Subject: N222379970 - Service Update
Internal Seam and Underbody Sealers Failed Adhesion Testing in
Plant

Models: 2023 Cadillac XT5
2023 Cadillac XT6
2023 GMC Acadia

N222379970 Internal Seam and Underbody Sealers Failed Adhesion Testing in Plant

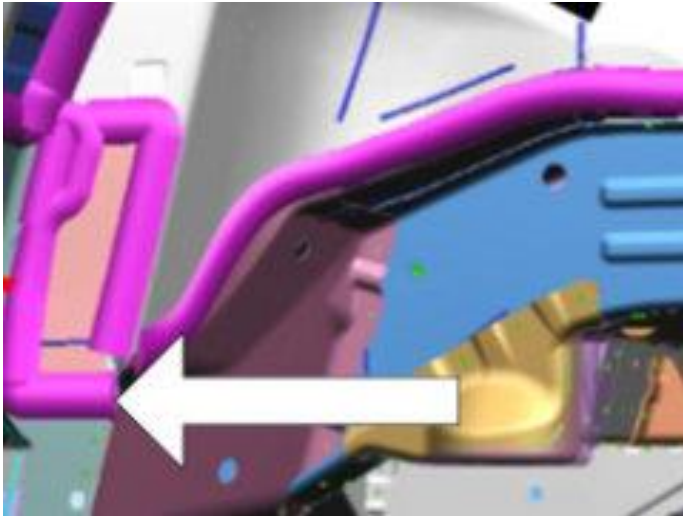
2. Locate the body sealer path indicated in purple in the graphic above.

6197153

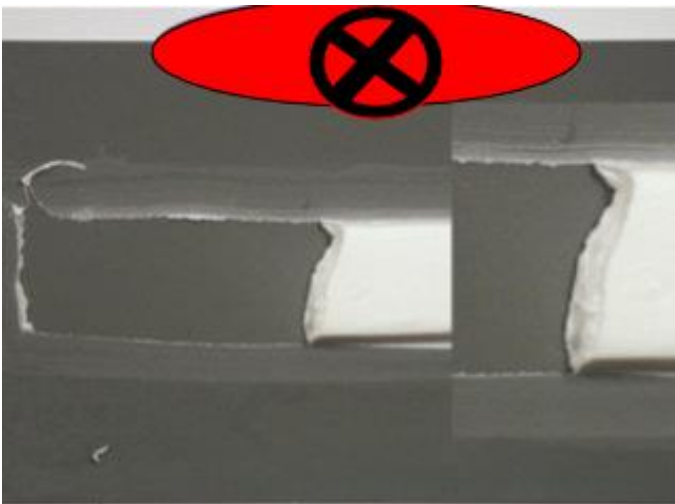
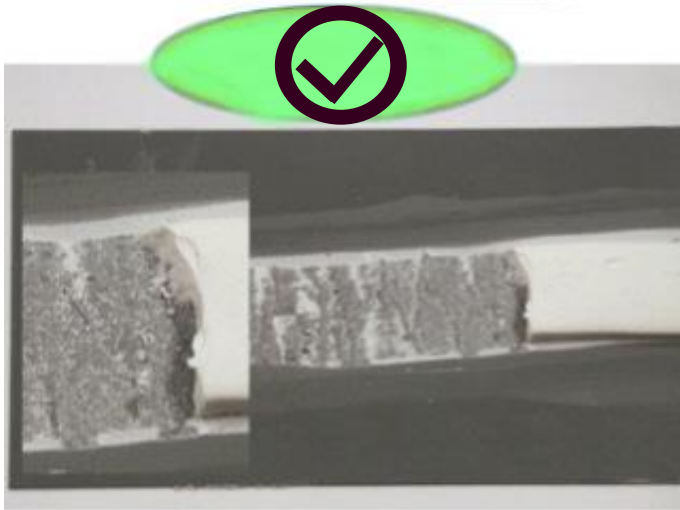
3. Starting in the lower front corner, use a stiff putty knife or a gasket scraper to attempt to lift the seam sealer from the body.

- If the seam sealer easily peels from the painted (E-Coat) surface, the material is not performing correctly. Proceed to step #4.

6193061

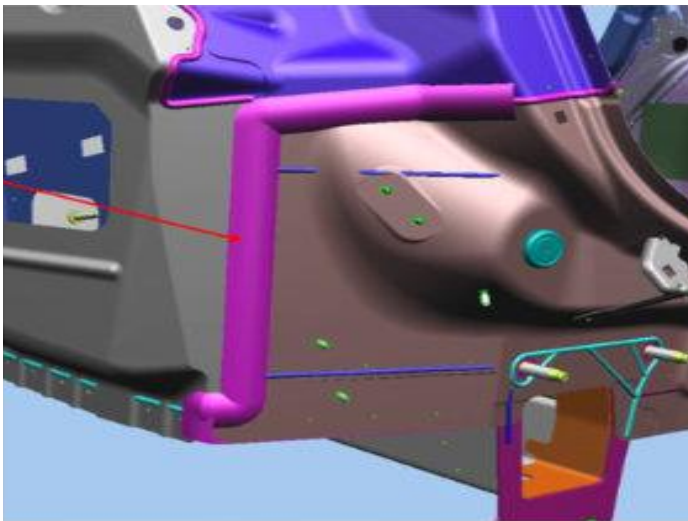
- If the seam sealer does not peel easily but separates leaving a partial covering of sealer on the painted (E-Coat) surface, no further action is required. Replace any seam sealer that is disrupted during the above step and reinstall the wheelhouse liner. Refer to *Rear Wheelhouse Liner Replacement* in SI.
4. Remove the right rear wheelhouse liner. Refer to *Rear Wheelhouse Liner Replacement* in SI.
 5. Remove the rear bumper fascia. Refer to *Rear Bumper Fascia Removal and Installation* in SI.
 6. Locate the seam sealer application in the following areas, identified in purple. The left side is shown, seal the area on both the left and right sides of the vehicle.
